**AMENDMENT NO. 1 JUNE 1993
TO
IS 6962 : 1991 3, 9-DIBROMOBENZANTHRONE,
TECHNICAL — SPECIFICATION**

(First Revision)

3, 9 Dibromobenzanthrone
C. A. S. Registry Number [81—98—1]

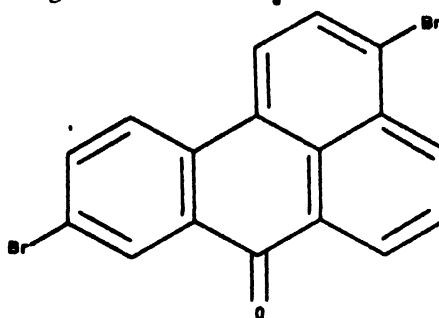
(Forword, second para, molecular formula and structural formula) —
Substitute the following for existing:

$C_{17}H_8Br_2O$
